IDAP REPORT

Property:	4-6 Underwood Road HOMEBUSH DA 2020/146
Proposal:	Change of use to a printing manufacturing facility, alterations and additions to existing structures to form one building, ancillary landscaping.
Applicant:	M Sande
Owner:	Underwood Homebush P/L
Date of lodgement:	13 August 2020
Notification period:	24 August 2020 to 22 September 2020
Submissions received:	Two
Assessment officer:	P Santos
Estimated cost of works:	\$550,000.00
Zoning:	IN1 - General Industrial - SLEP 2012
Flood affected:	Yes
RECOMMENDATION OF OFFICER:	APPROVAL

Figure 7. Extract of the survey plan with the easement emphasised with red outline (source: Anthony & Associates Surveying, dated 10/09/2019)

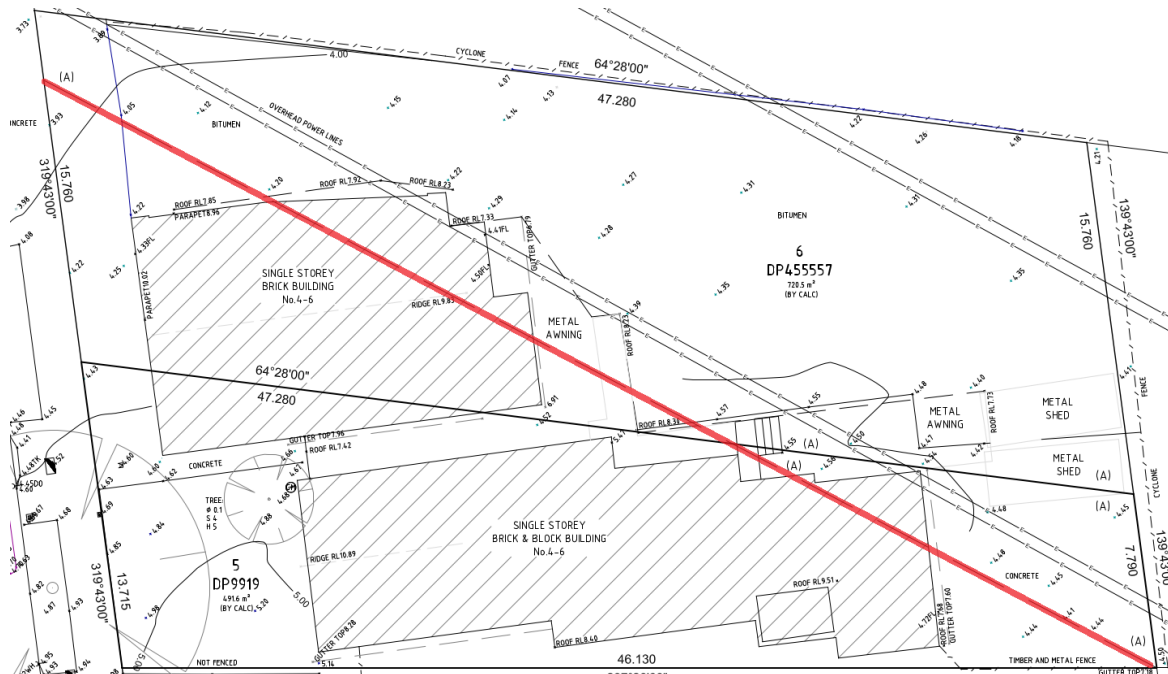
The northern part of site is traversed by an electricity easement from east to west, as shown in Figure 7 below.

Pursuant to Clause 45 of the Infrastructure SEPP, the application was referred to Ausgrid. As a response, Ausgrid has provided the following conditions for any activities within the electricity easement:

- *"All construction works on or near the easement and/or powerlines must adhere to the Safework NSW - Work Near Overhead Powerlines: Code of Practice, 2006."*
- *"No vehicles, plant or equipment having a height exceeding 4.6 metres are to be brought into the easement site without written approval from Ausgrid."*
- *"Vehicles brought into the easement, with a height less than 4.6m but having an extension capable of extending greater than 4.6m above ground, must not have that extension operated at all whilst within the easement."*
- *"Adequate removable protection must be installed to prevent vehicles inadvertently colliding with the transmission tower. This proposed form of protection must be forwarded to Ausgrid for review and consent."*
- *"No buildings/structures or parts thereof constructed may encroach the easement."*

- All construction works on or near the easement and/or powerlines must adhere to the Safework NSW - Work Near Overhead Powerlines: Code of Practice, 2006
- No vehicles, plant or equipment having a height exceeding 4.6 metres are to be brought into the easement site without written approval from Ausgrid.
- Vehicles brought into the easement, with a height less than 4.6m but having an extension capable of extending greater than 4.6m above ground, must not have that extension operated at all whilst within the easement.
- Adequate removable protection must be installed to prevent vehicles inadvertently colliding with the transmission tower. This proposed form of protection must be forwarded to Ausgrid for review and consent.
- No buildings/structures or parts thereof constructed may encroach the easement.
